Product information - BMW brake pads | HELLA

BMW brake pads

8DB 355 009-271 / 8DB 355 015-391

New allocation of the brake pads

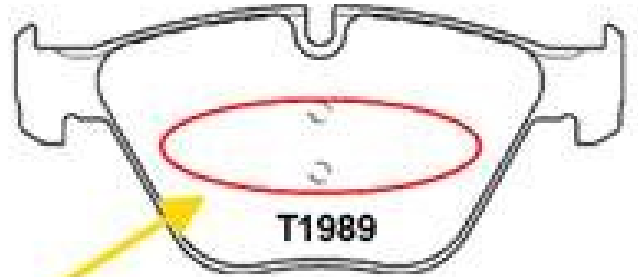
The difference between both brake pads is the missing retaining spring (A) on the brake pad 8DB 355 015-391 / T1989 on the fist side.

Brake pads 8DB 355 009-271 / T1230 shall still be used for the M models of the 1 series (E82) and 3 series (E90-91).

All other models are now covered by 8DB 355 015-391 / T1989. 8DB 355 015-391 / T1989 can also be retroactively used for all vehicles linked.
